RICHMOND UPON THAMES LOCAL PLAN
Publication consultation on the Council's final version of the Plan and final SA report
(Regulation 19)
RESPONSE FROM PROSPECT OF RICHMOND

Response from Prospect of Richmond, dated 31 July 2023 (extension granted by Richmond upon Thames Council ref email from [REDACTED] to Peter Willan dated 20 July 2023)

Table 1: All responses received (to question 4 on the [response form](#)) in relation to the strategic vision (section 3 of the draft Plan) (as received) and the Council's officer response

Kew Character Areas (G1 ODP), Urban Design Study Dec 2021

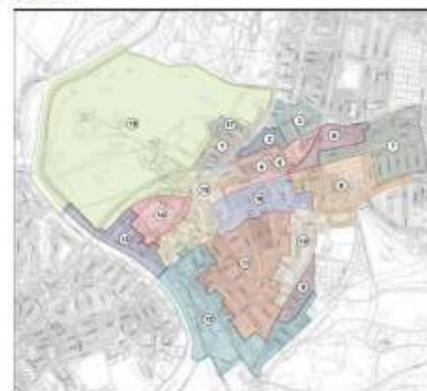
Place Definitions. Based on Section 3 – Character Areas in Arup’s 432-page Urban Design Study, The Old Deer Park is incorrectly grouped with the Royal Botanic Gardens, Kew in Character Area ‘G1 – Kew Gardens and Riverside’ under the overall heading ‘G –Kew’. Like Richmond Park, the Old Deer Park should be covered by its own Character Area as ‘F4 – The Old Deer Park’, under the overall heading of ‘F – Richmond & Richmond Hill (sic)’. On this basis, other sections of Arup’s Urban Design Study and to the Draft Local Plan need to be adjusted accordingly.

Indeed, more fundamentally, the proposed structure of ‘Character Areas’ as set out in Section 3 et seq. in Arup’s Urban Design Study needs to be challenged. The proposed boundaries relate neither to the present Ward boundaries nor to the existing conservation area boundaries. They should surely be based for the most part on the present conservation areas and in this case the Old Deer Park Conservation Area.

Confusingly, the extant ‘Richmond & Richmond Hill Village Plan’ (2016) comprises all four areas plus Richmond and Richmond Hill residential (F2), North Sheen Residential (F3) and the Old Deer Park which is included in the Local Plan as Placed Based Strategy for Kew and has its own Old Deer Park Conservation Area Statement and SPD.

See response to Comment 618 regarding the character area boundaries.

Richmond & Richmond Hill. Urban design Study Dec 2021

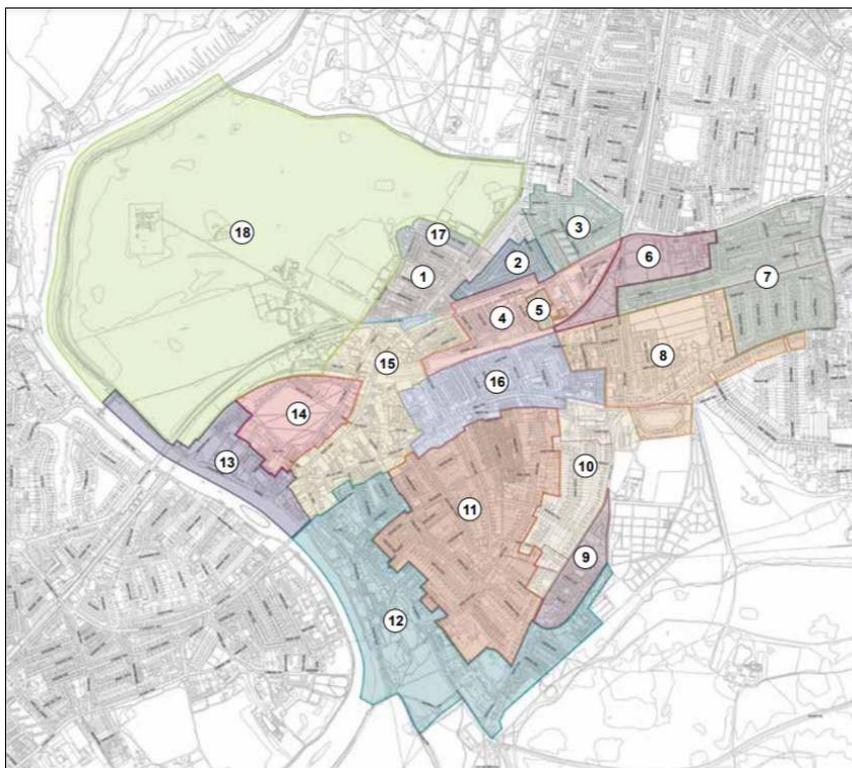
- Local Plan Section 11 heading is 'Place-based Strategy for Richmond & Richmond Hill'. The study area is defined as 'Richmond Town Centre and Riverside, and the residential and mixed use areas into Richmond Hill and North Sheen'. These are character areas F1, F2 and F3 in the Urban Design Study 2021'. 'Richmond Town Centre and Riverside' (F1) is described as including Richmond Green. We believe the four components of Richmond Town should be separately identified in line with the boundaries of the Conservation Areas for Central Richmond, Richmond Green, Richmond Riverside and Richmond Hill and that the character areas should match the Conservation Area boundaries.

- Confusingly, the extant 'Richmond & Richmond Hill Village Plan' (2016) comprises all four areas plus Richmond and Richmond Hill residential (F2), North Sheen Residential (F3) and the Old Deer Park which is included in the Local Plan as Placed Based Strategy for Kew and has its own Old Deer Park Conservation Area Statement and SPD. We note parts of the two Riverside Conservation Areas are on the Twickenham side of the river Thames whereas the Local Plan boundary appears to be the centre of the river.

- We have extracted the Character Area Map from Arup's Urban Design Study Dec 2021 and provided a Conservation Area Map so that members of the community reading our response can better understand the context.

Figure 2 Extract from Local Views map July 2022

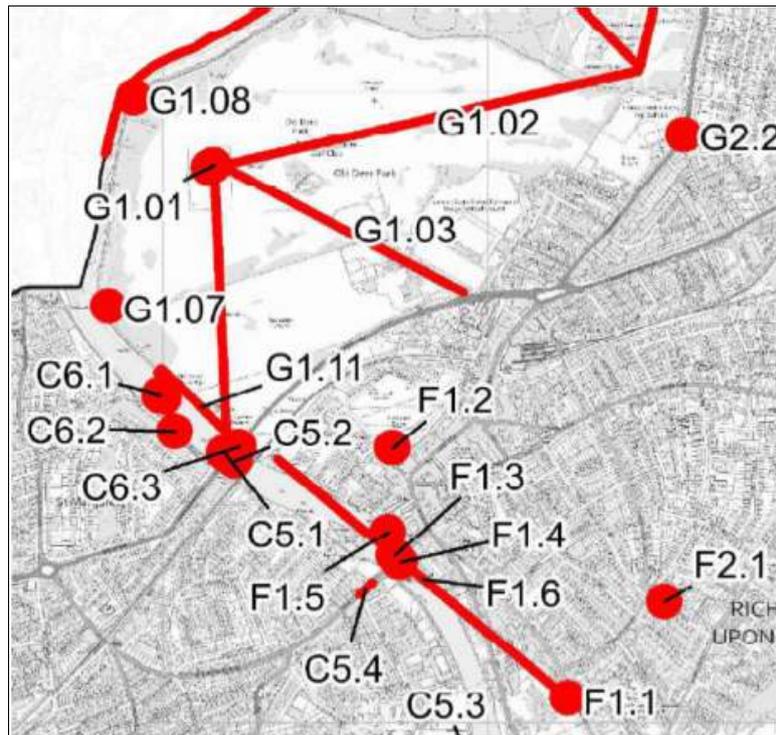
- i. Detail is insufficient to be able to identify viewing locations and specific view end points (often the end points can be guessed at but not for all of the views).

Figure 5 F1.2 Richmond Green, Townscape New proposed by draft SPD

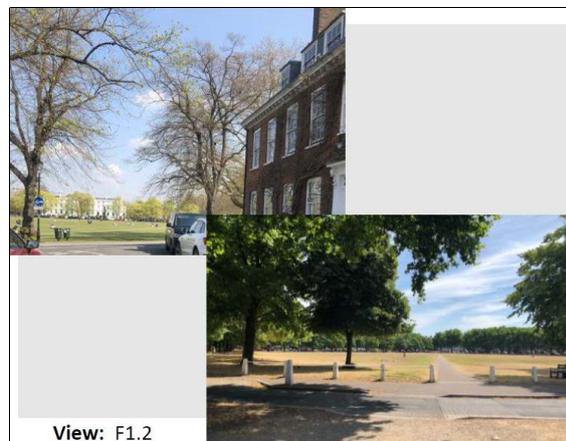
- ii. F1.1 *Richmond Terrace, Richmond Hill (Prospect Adopted)*. Half the image is taken up by the Terrace, which seems excessive.
- iii. F1.2 *Richmond Green Townscape New*. Two images are provided. These are not perhaps the best selection and are similar in view. We suggest four images showing views of all four sides and possibly trees without leaves would be preferable although the trees are of substantial significance throughout the seasons. We recommend the viewing locations be at any point 360 degrees around Richmond Green and should include Maids of Honour Row as the fourth side of the Green but this has been omitted from the description. Now that the development of the House of Fraser site is being considered we suggest it is opportune to restore the view as a protected view along with the townscape views from the rest of Richmond Green. Figure 6 shows the existing view with ugly plant and machinery on top, which in any development we suggest should be removed and without an additional floor and plant-room on top.
